# UNITED STATES PATENT AND TRADEMARK OFFICE

APPLICATION NO.	FILING DATE	FIRST NAMED INVENTOR	ATTORNEY DOCKET NO.	CONFIRMATION NO.
10/646,863	08/25/2003	Tae Hwan Jung	1594.1274	1800

**Office Action Summary**

This is a first office action on the merits of application SN 10/646,863.

Cherry '747 Figure 7

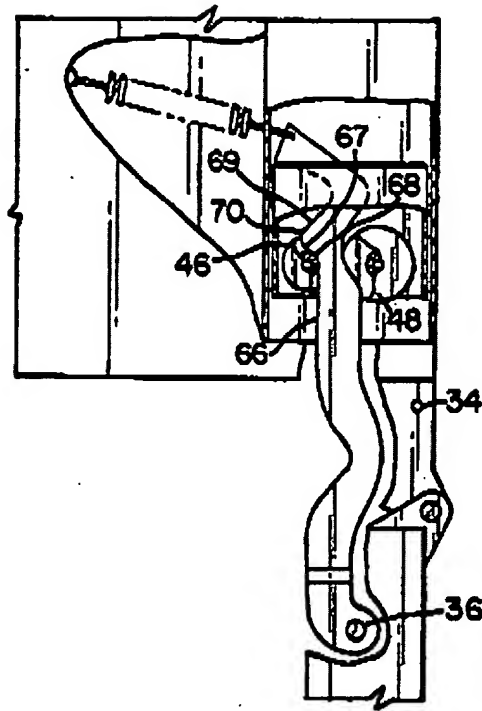
7. Claims 1, 2, 6, 7, 12, 14, 28, 29, 34, 35, and 40 are rejected under 35 U.S.C. 102(b) as being clearly anticipated by U.S. Patent 5,220,747 to Cherry. Cherry '747 discloses a door control device for a refrigerator (10) having a refrigerator door (14). A movable body (38) is coupled to the refrigerator door (14). Wherein the movable body (38) is arranged to move in opposite directions in accordance with opening and closing actions of the refrigerator door. A control unit (54, 54a) controlling an opposite directional movement of the movable body in a multi-stage manner.

Cherry '747 Figure 4

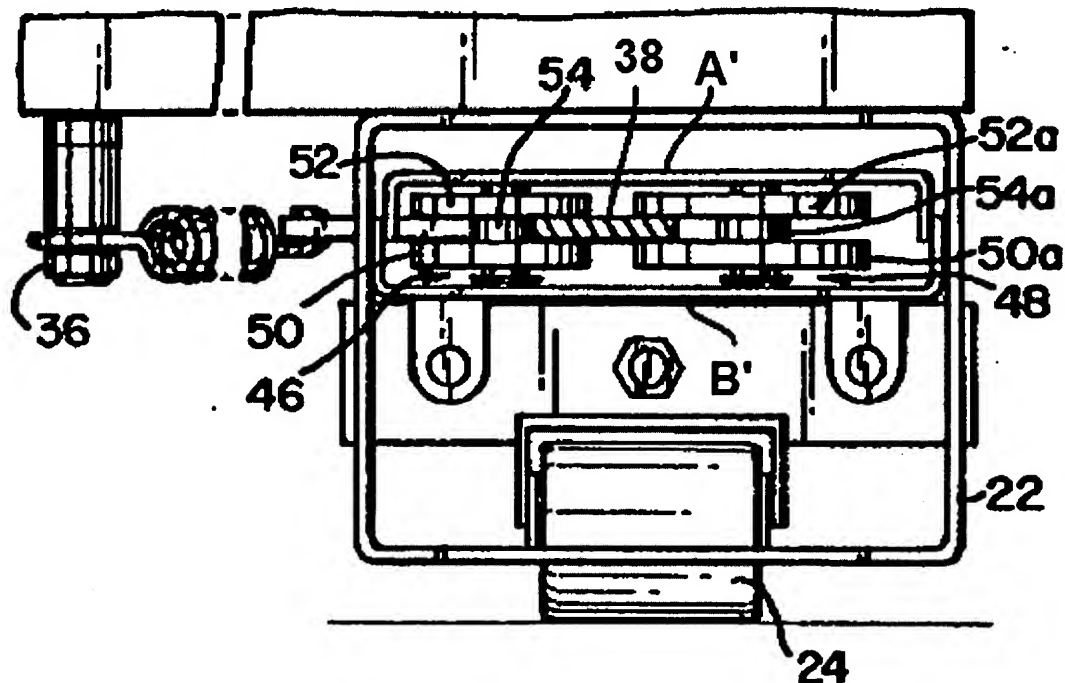
8. Regarding claims 14 and 28, the refrigerator (10) is defined as a cabinet (11) with a storage compartment (12). The door (14) is hinged to the cabinet (11) to close the storage compartment (12). The device is disposed in a leg casing (22) at a lower portion of the refrigerator (10) as best shown in figure 1.

9. Regarding claims 2 and 29, a guide element (50, 52, 50a, 52a, A', B') contains the movable body (38) and guides the opposite directional movement of the movable body.

10. Regarding claims 6 and 34, the movable body (38) is provided with a plurality of grooves (65, 68) formed along a longitudinal side surface.

11. Regarding claims 7 and 35, the control unit (54, 54a) comprises a locking unit (54, 54a) selectively engaging with the plurality of grooves provided to the movable body.

12. Regarding claims 12 and 40, the grooves (65,68) of the movable body (38) are smoothly curved to form a waved configuration.

Jeynes '551 Figure 1

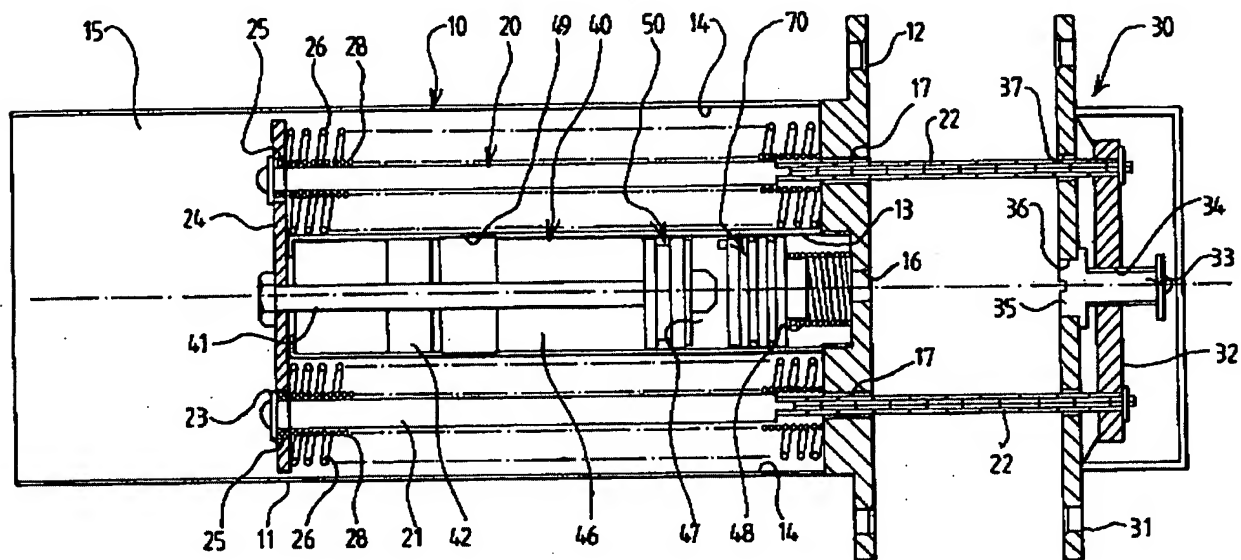
19. Claims 18-27 and 45-53 are rejected under 35 U.S.C. 103(a) as being unpatentable over U.S. Patent 5,220,747 to Cherry in view of U.S. Patent 5,706,551 to Jeynes. Cherry '747 discloses every element as described above and tension spring (56) attached to the rear of the moveable body (38). Cherry '747 does not disclose expressly a dampening unit. Jeynes '551 discloses a dampening unit (10) to close a door. The dampening unit (10) uses an elastic support unit in the means of two parallel compression springs (26) to drive the shafts (22) into the body. The compression springs are connected to a support member (30) by shafts (22). The dampening unit (10) uses a hydraulic damper (40) to dampen the rate of rearward movement during closing action, thus retarding energy generated from the door. At the time of the invention it would have been obvious for a person of ordinary skill to take the device of

Cherry and replace the tension spring with the dampening unit of Jeynes by attaching the support member to the moveable body so that the closure rate of the door is controlled.
